DA CP 13-001

**PROPOSED BEACHFRONT REVETMENT WALL
NO.8 BERRIMA CRESCENT, UMINA BEACH**

**DRAFT ASSESSMENT REPORT & RECOMMENDATION
PREPARED FOR THE NSW COASTAL PANEL**

MARCH 2014

Figure 2 - Proposed Revetment Wall Design

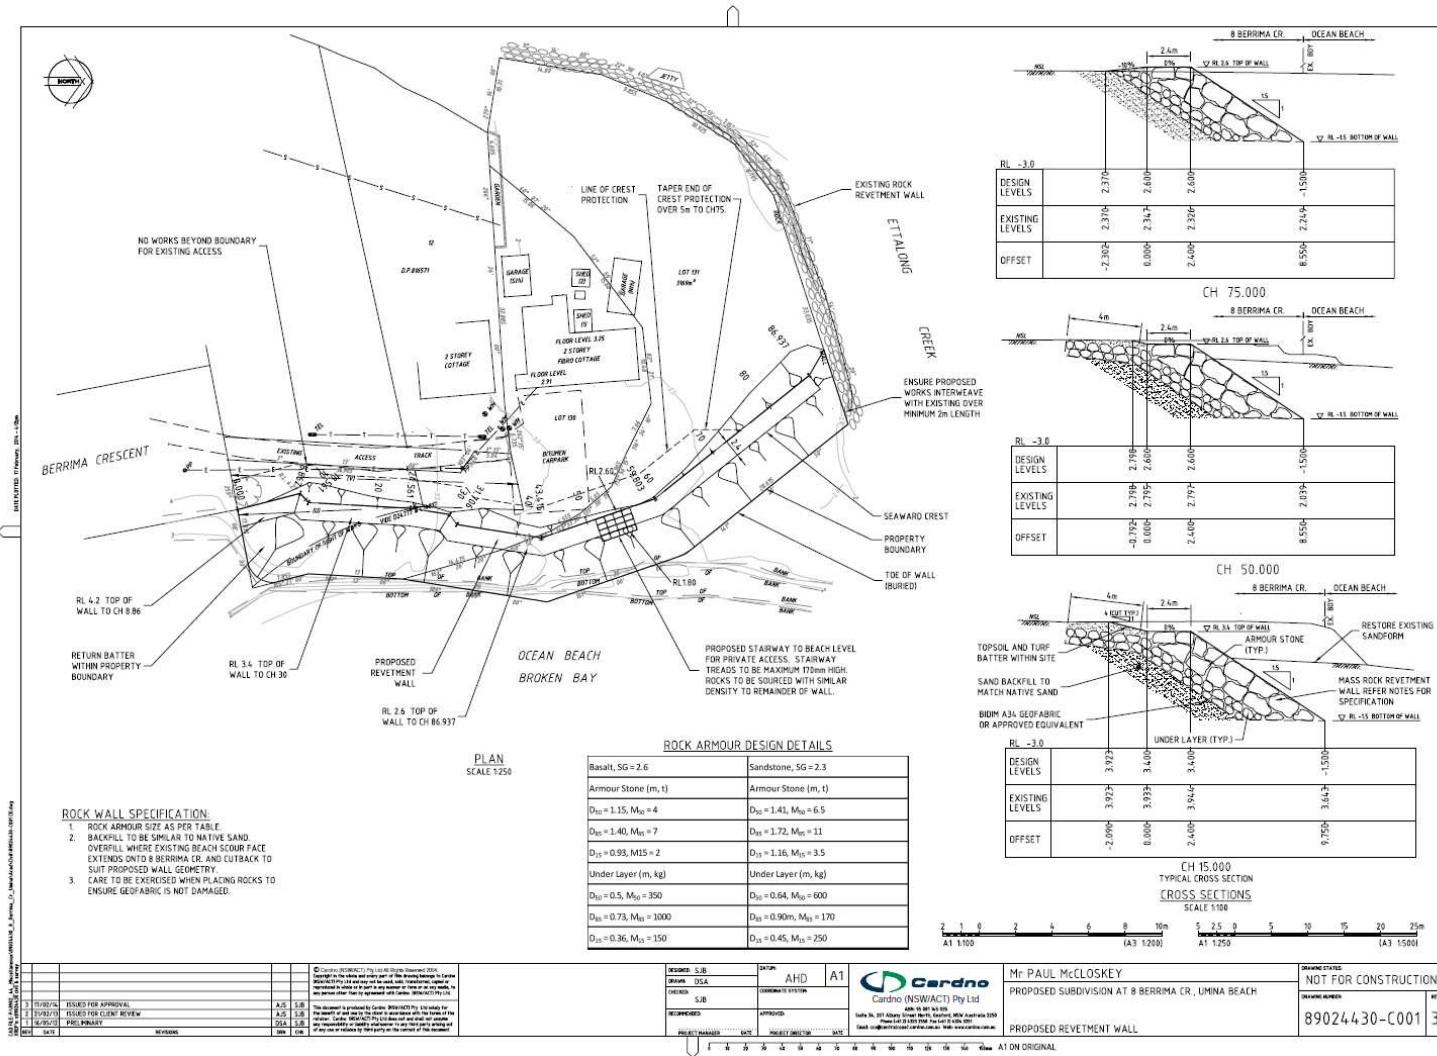
- Clarification on the location of the proposed return of the wall as depicted in drawing No. 89024430-C001. The application states the wall is to be constructed entirely on the applicant's (private) land. However, this figure indicates the southern return of the wall is to be constructed beyond the property boundary, and extending onto public land. If the return is to be constructed on public land, landowner's consent will need to be submitted as part of the development application documentation;

- Clarification is sought on the design slope of the seawall. There is a discrepancy between the information in the Statement of Environmental Effects which shows the slope of the wall is 1V:1.5H compared to the design of the wall as shown in drawing No. 89024430-C001 indicates a relatively steep wall design of 1.5V:1H;

- Further information on the justification for the proposed design in terms of its adequacy across its anticipated design life. Specifically:
 - the wall is considered to be of a relatively low height and therefore potentially susceptible to overwash and possible failure,

- the wall has a relatively shallow toe and therefore is potentially susceptible to undermining,
 - the wall design has only a primary and no planned secondary rock fill layer, and therefore may be potentially susceptible to a compromised structural integrity resulting from wave run-up and overwash processes, and

- Information about the proposed method to address these design issues to maintain structural integrity such as deeper toe and higher crest levels, a double layer wall, wall slope and the ability to 'top up' the wall into the future if required;

- Drawing 89024430-C001: A revised revetment wall proposal (Figure 2)
- Drawing 89024430-C002: A revised erosion and sediment control plan (Figure 4)
- A revised coastal engineering assessment (Appendix D).

The design of the revetment wall has been amended to return the southern end wall batter wholly within the property boundary and to amend the cross section and armour stone detail along with the accompanying revised coastal engineering assessment that addresses the various coastal engineering and revetment wall design matters raised the correspondence.

Figure 3 – Design Schematic for Private and Council Seawall Revetment

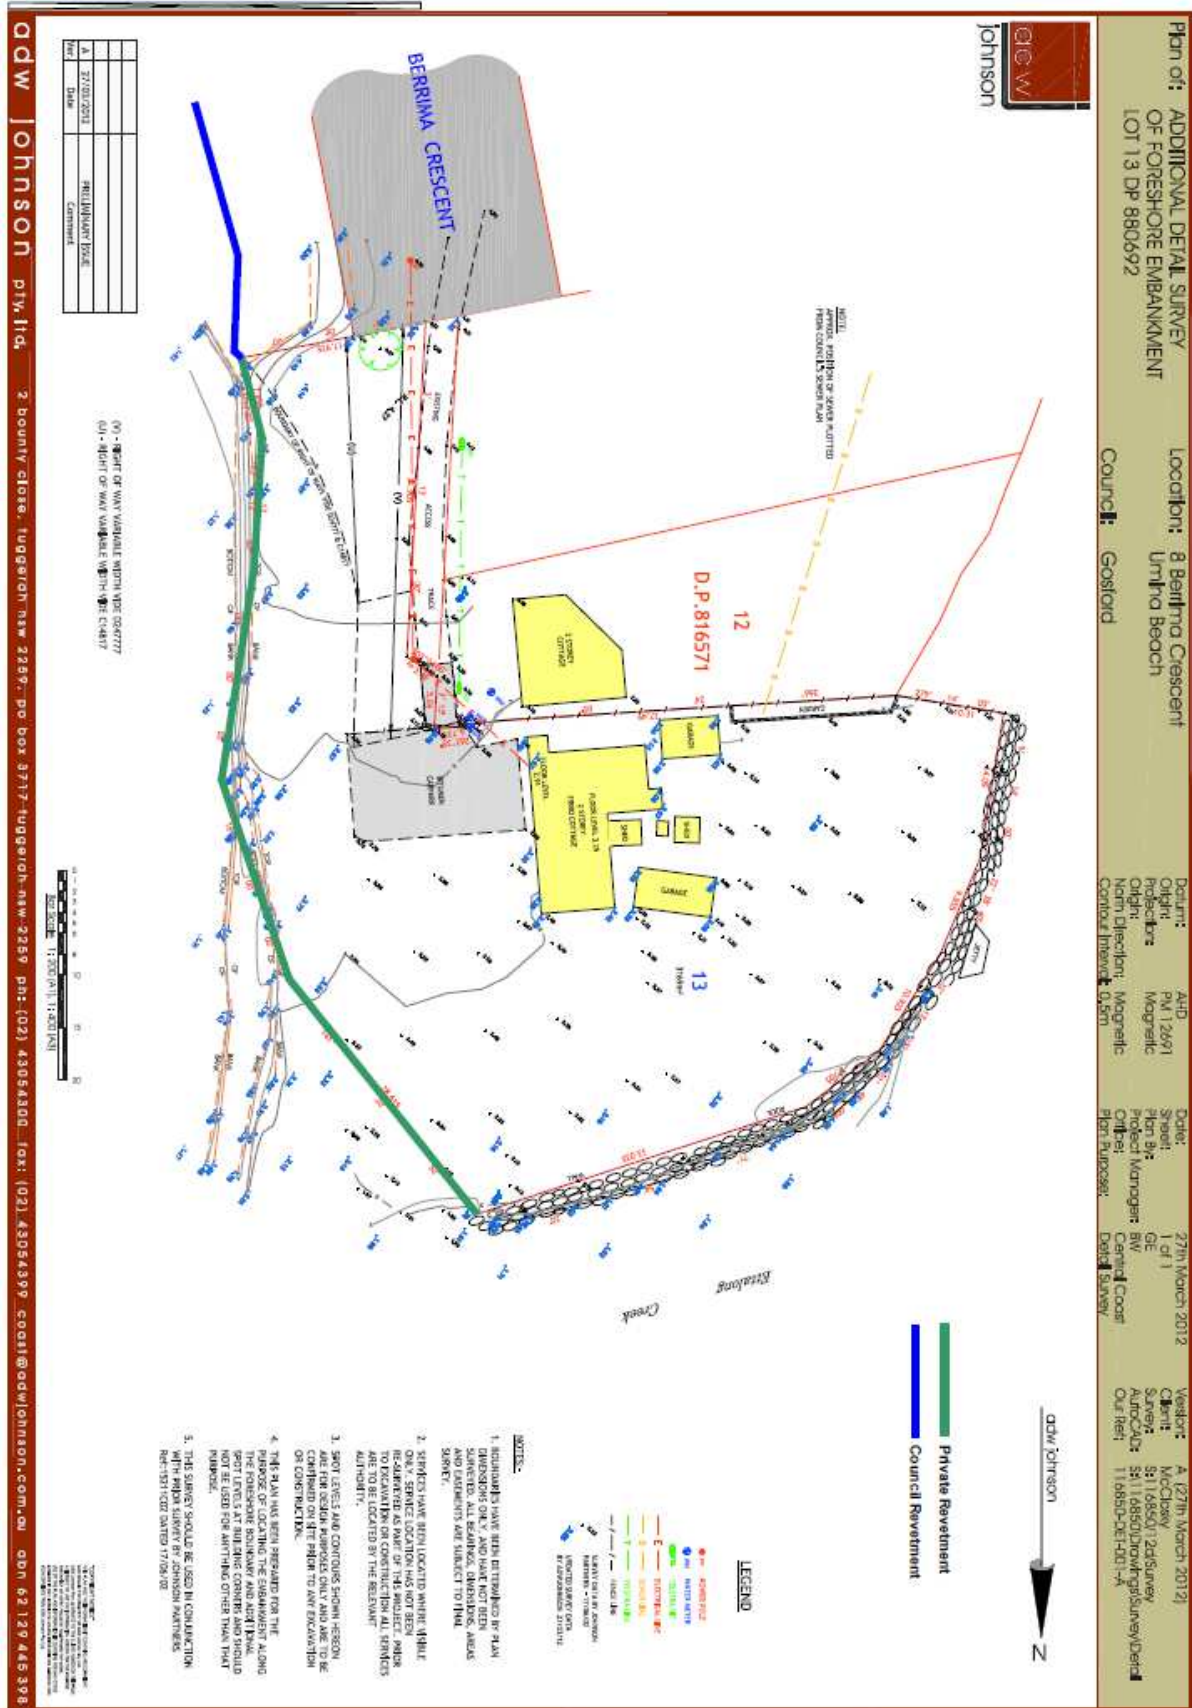
The DA advises that the length of wall is intended to be constructed in two sections (Figure 3). The first of these sections (green line) is to be constructed by the owner(s) whose land lies landward of this line – solely Mr McCloskey. The second section (blue line) would protect public land and the applicant has proposed would be built by GCC. The DA advises this may not necessarily proceed at the same time as the proponents intended structure and is

subject to council's intentions. The proponents section of the revetment (green line) would be contained entirely on the owners land, although the DA acknowledges would require some excavation during construction on public land, and therefore associated access and reinstatement matters will need to be addressed. The proposed revetment also includes a return section of the wall at the southern end in order to prevent outflanking. This has been amended from the original DA (received 22 August 2013) to be wholly contained within the property boundary (Figure 3).

The DA also recognises that should Council not proceed with their section of the revetment wall sequentially/simultaneously with Mr McCloskey's proposed works, then 'end effects' may occur that would exacerbate erosion on this unprotected area south of the proposed works. The DA and accompanying revised coastal engineering assessment advises this estimated loss of sand to be no more than 200m³, with a maximal erosion increase of 4m, extending south for 28m, and suggests beyond which point no end effects would occur (Cardno, 2014).
